# Technical Service Bulletin

SUBJECT:		No: <b>TSB-18-13-001</b>	
<b>MIL ILLUMINATION WITH DTC P0068</b>		DATE: <b>June 2018</b>	
		MODEL: <b>2018 Eclipse Cross</b>	
CIRCULATE TO:	<input type="checkbox"/> GENERAL MANAGER	<input checked="" type="checkbox"/> PARTS MANAGER	<input checked="" type="checkbox"/> TECHNICIAN
<input checked="" type="checkbox"/> SERVICE ADVISOR	<input checked="" type="checkbox"/> SERVICE MANAGER	<input checked="" type="checkbox"/> WARRANTY PROCESSOR	<input type="checkbox"/> SALES MANAGER

## ECU REPROGRAMMING CHART

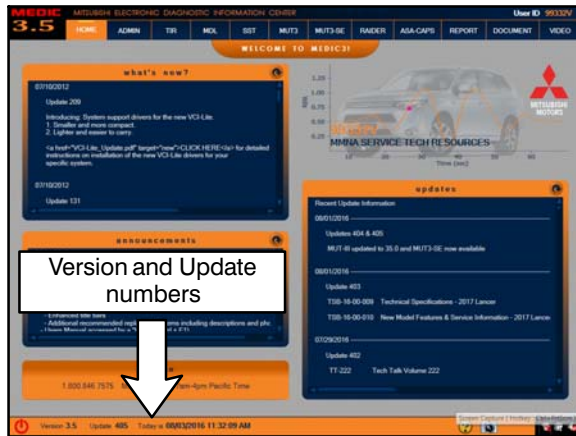
During turbocharged operation, DTC P0068 may set when Mass Airflow Sensor Plausibility Monitoring does not recognize turbocharged operation. New software is available that optimizes this monitoring to be able to recognize turbocharged operation.

This TSB instructs dealers to reprogram the engine ECU with updated software to correct the issue.

Model	ECU Part Number	Data No.	Software Part Number	
			Previous	New
2018 Eclipse Cross	1860D116	1862C870	1860D11602 1860D11601	1860D11603
